BYLAW C-7991-2020

A Bylaw of Rocky View County, **in the Province of Alberta, to adopt** the Ascension Conceptual Scheme

SCHEDULE 'A'
FORMING PART OF BYLAW C-7991-2020

A Conceptual Scheme affecting Block 6, Plan 8710757, NE-18-25-2-W5M; Block A, Plan 9212196, SE-19-25-2-W5M; a portion of SE-19-25-2-W5M; and SW-19-25-2-W5M, herein referred to as the Ascension Conceptual Scheme.

Figure 19 - Internal Storm Water Servicing Plan

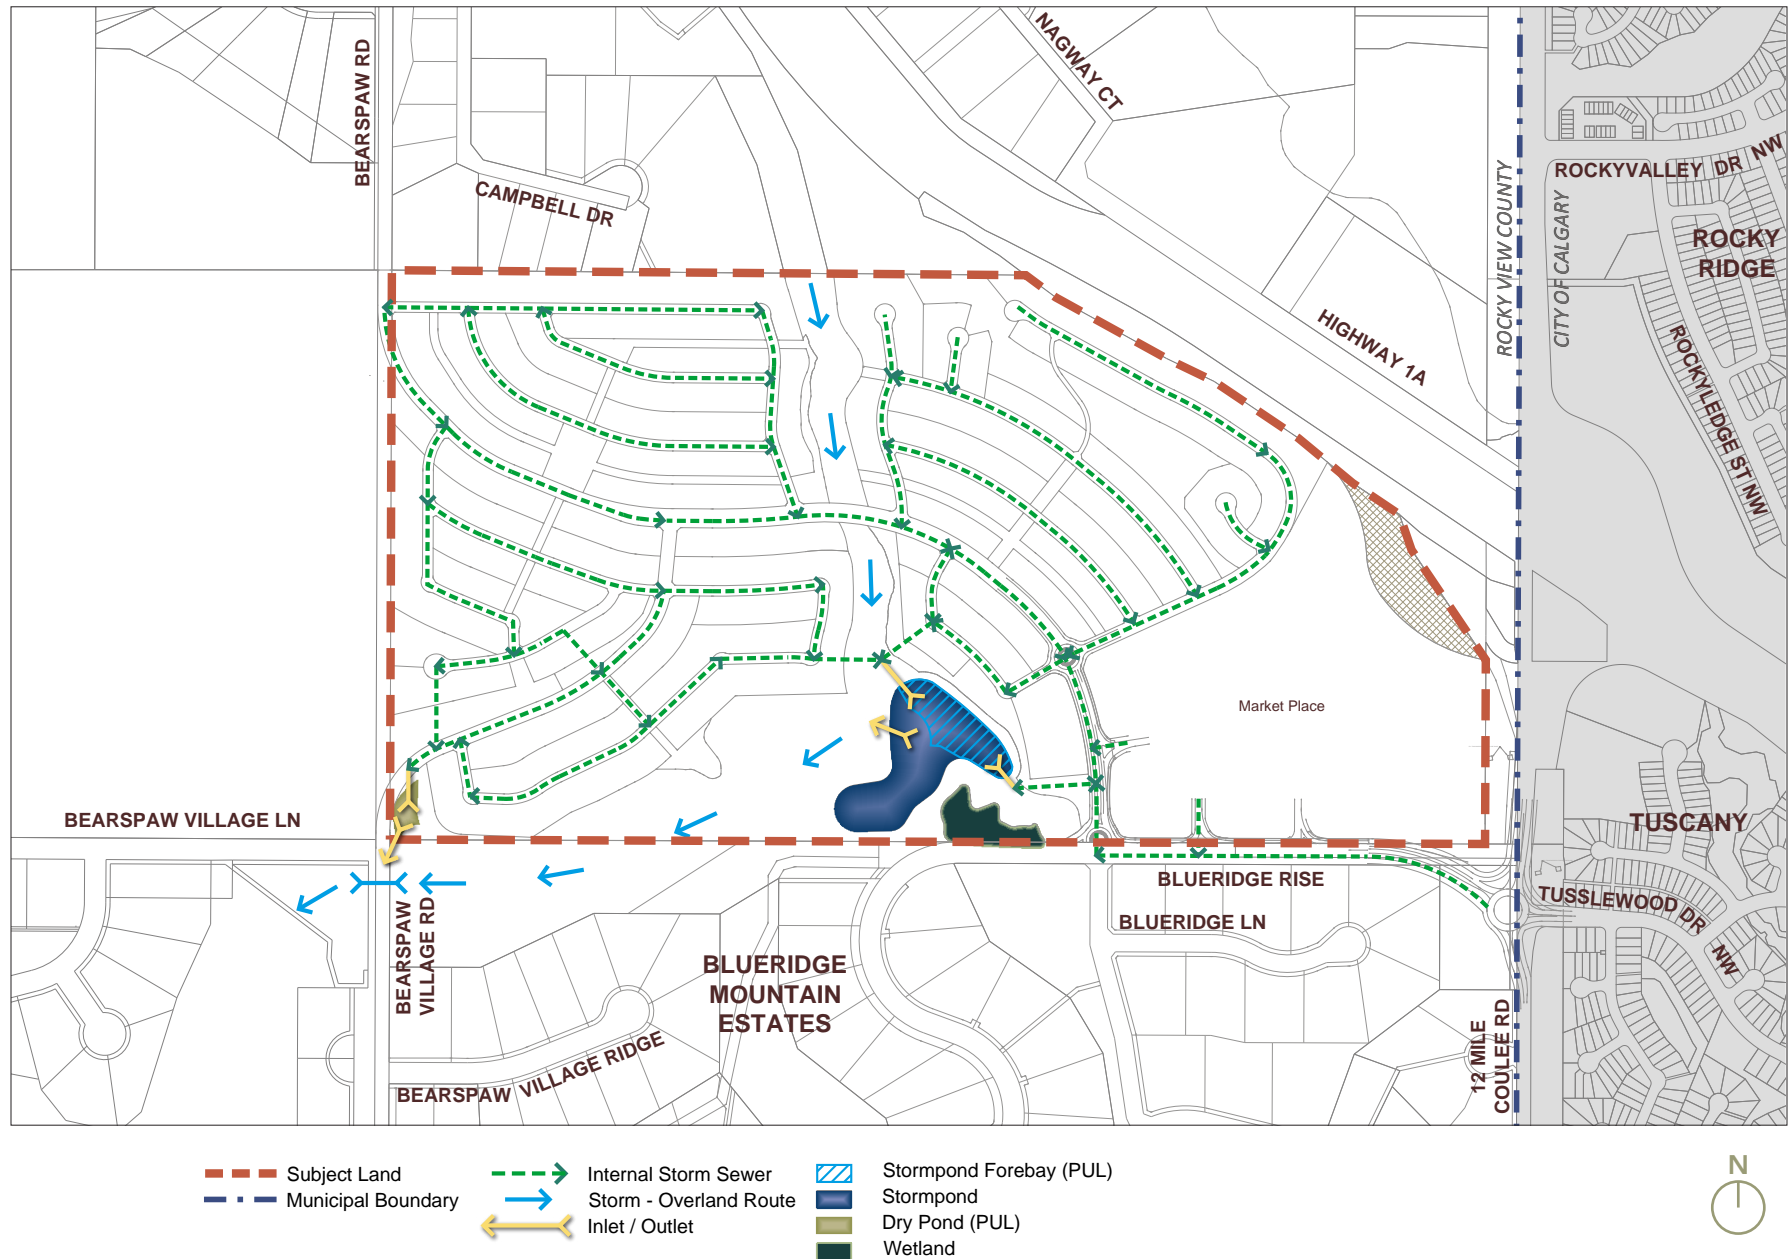
Formerly Figure 20 - Figure was updated

Figure 20 - Regional Water Servicing Plan

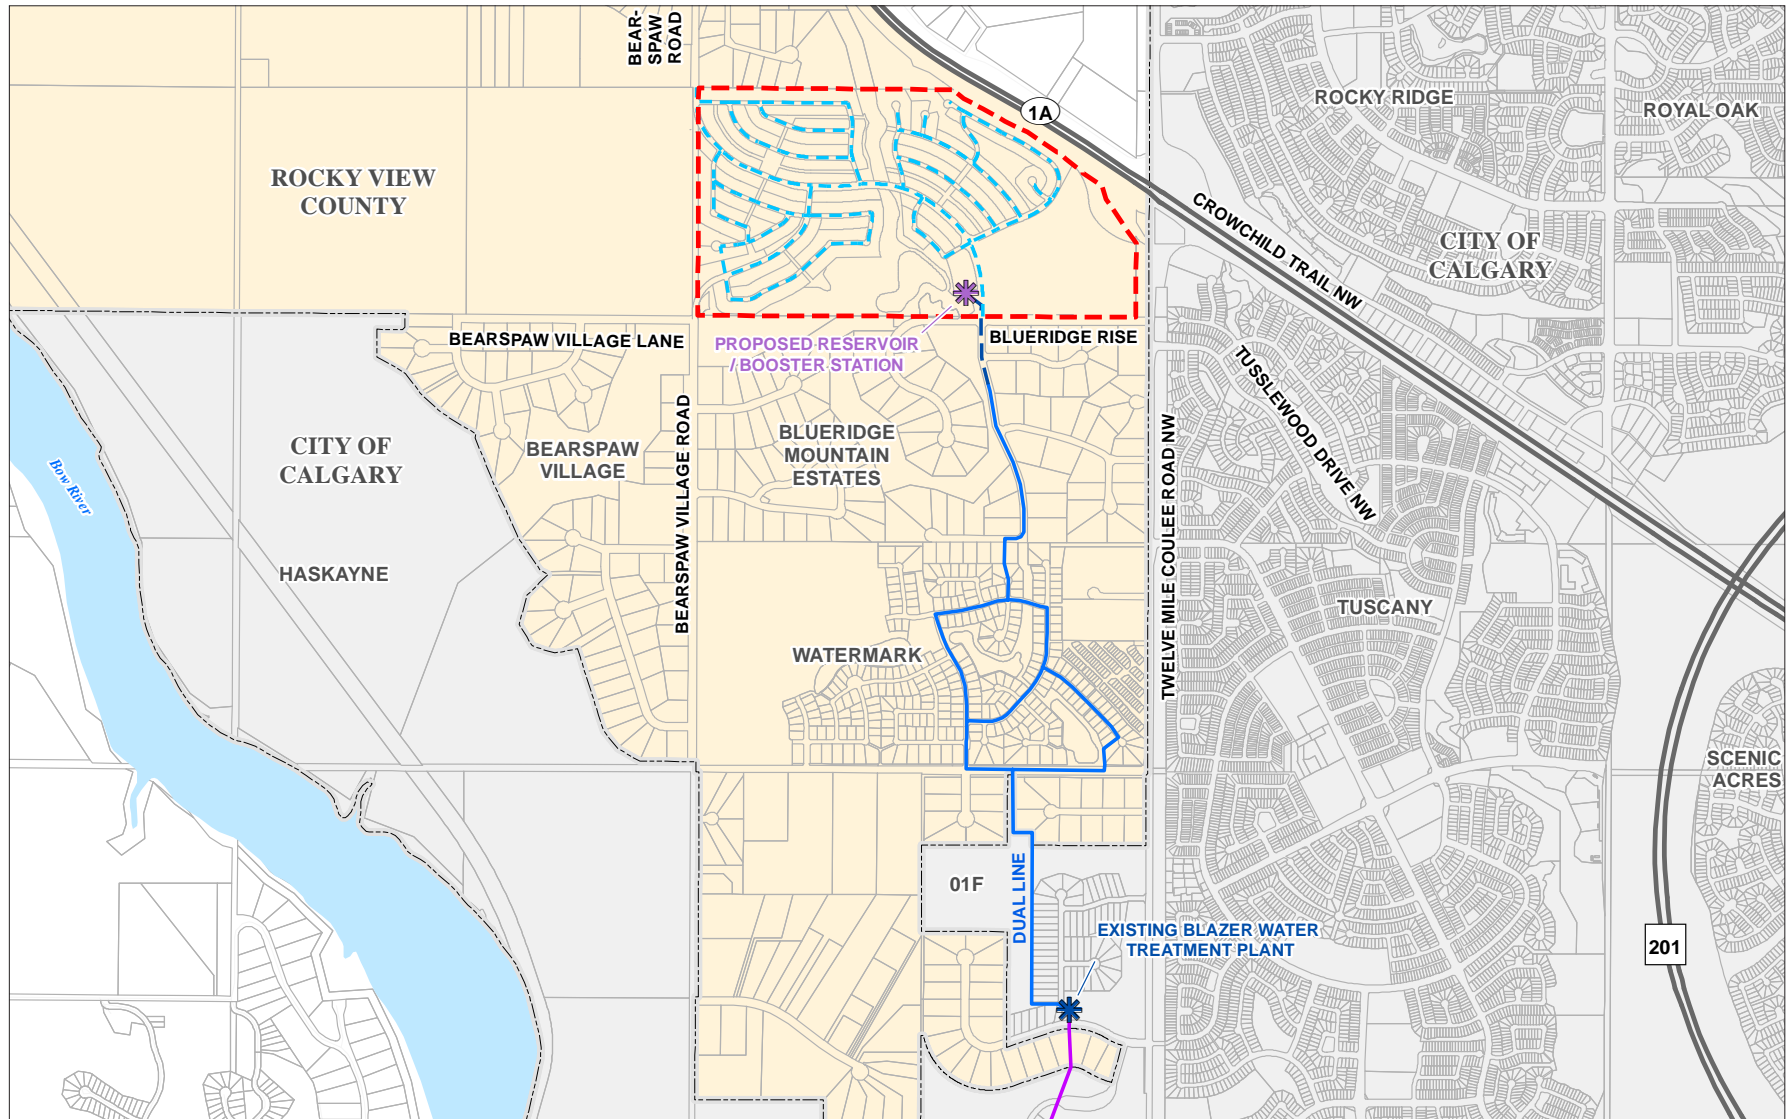
Upgrades will include expansion of the Blazer Water Treatment Plant at its existing location plus the addition of a ~~booster station and~~ Treated water reservoir **and booster station** within the development site, **as demonstrated on Figure 21 - Internal Water Servicing Plan**. There will be no impact on the groundwater levels or on existing wells on adjacent rural properties because the water supply ~~is coming~~ **will come** directly from the Bow River.

Formerly Figure 21 - Figure was updated

Figure 22 - Regional Wastewater Servicing Plan

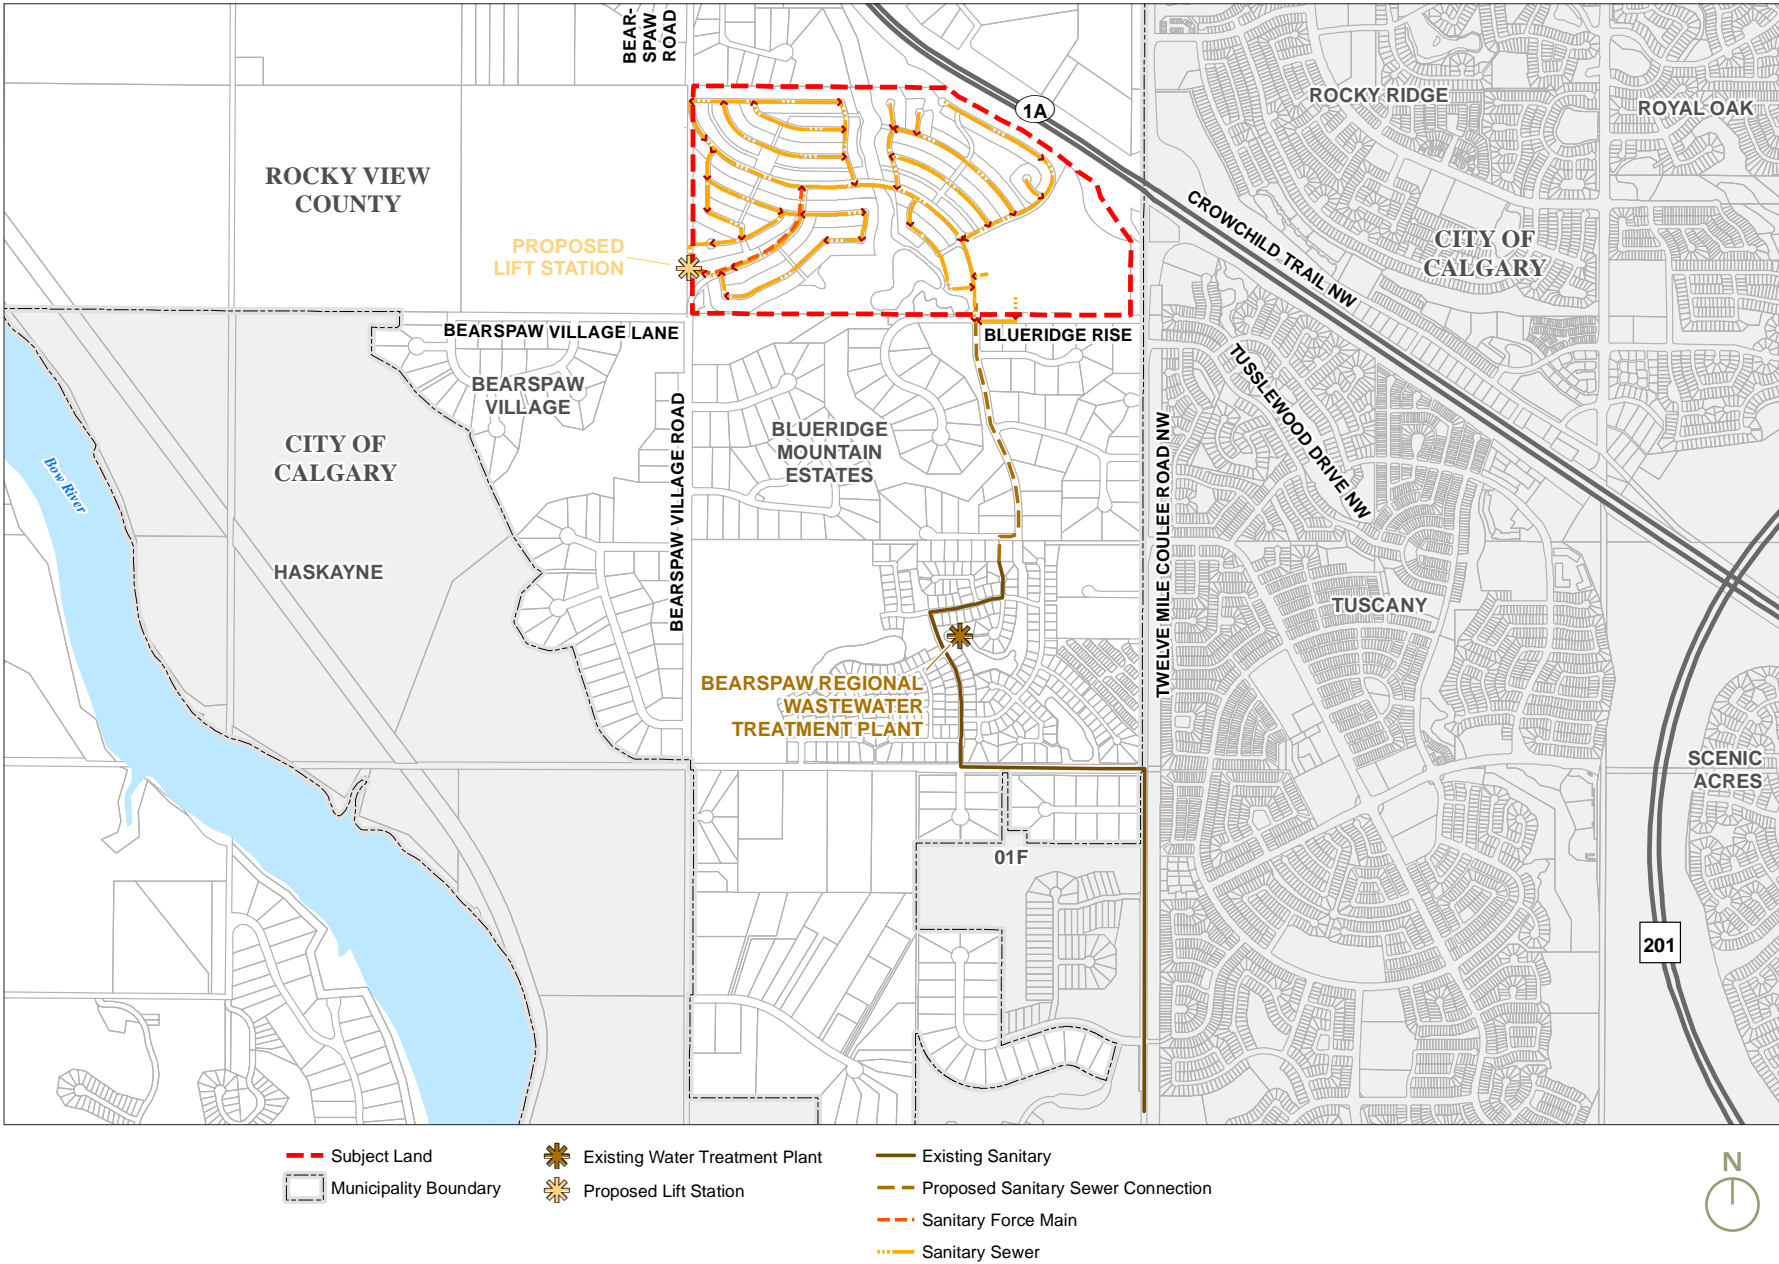
Formerly Figure 23 - Figure was updated
